RESPONSE TO SCHEDULE 5 NOTICE

Kaug Refinery Services Limited

VERSION:	1.1	DATE:	04/10/2024		
DOC. REF:	2765-010-M	AUTHOR:	DY	CHECKED:	KRS
CLIENT NO:	2765	JOB NO:	010

This document provides responses to the Notice of Request for Further Information (Schedule 5 Notice) issued by the Environment Agency (EA), dated 05/09/2024, requesting additional information for the application for a bespoke installation at Merse Road, Redditch (application ref: EPR/BP3421SC/A001).

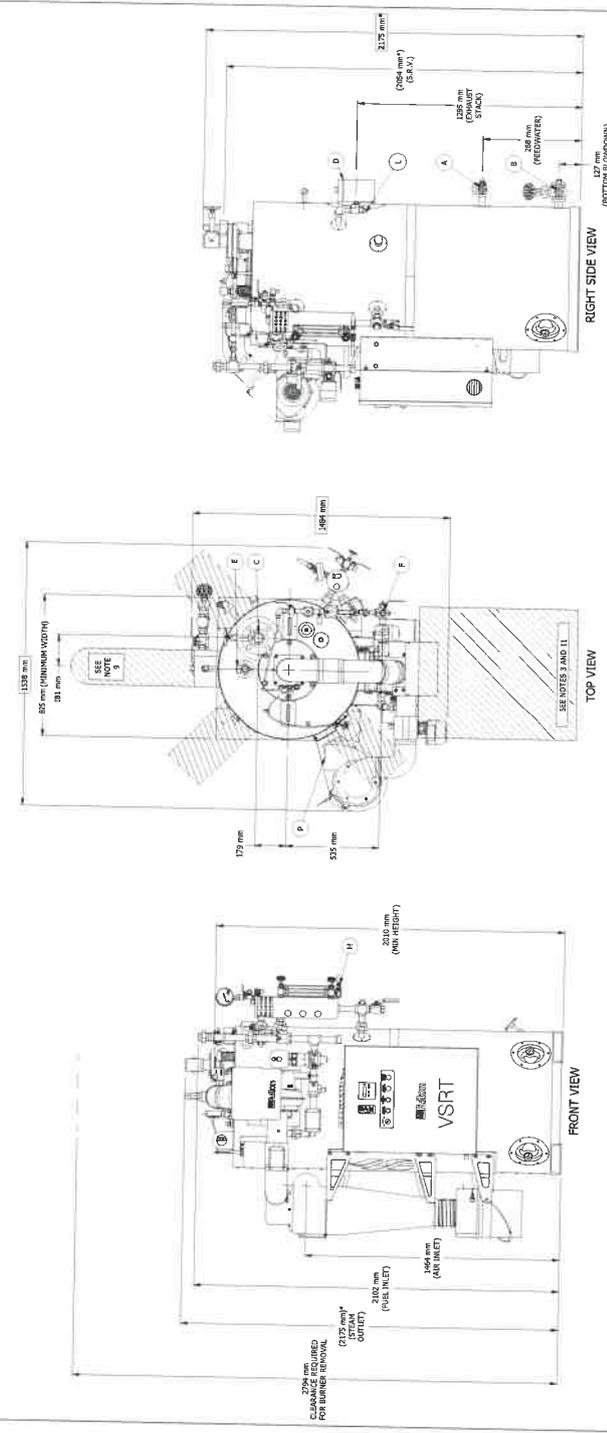
1a) Emissions to Air – information informing the Air Quality modelling report.

i) Provide the parameters used to calculate the emission rates for emission point 'A2'.

The emission rates for emission point A2 were based on manufacturer information for the steam boilers which was provided by the applicant. Reference should be made to Appendix I for technical datasheet for the boilers. Emission rates are contained on page 3 of the document. The higher of the emission rates provided for each pollutant were used in the model to ensure a worst case assessment.
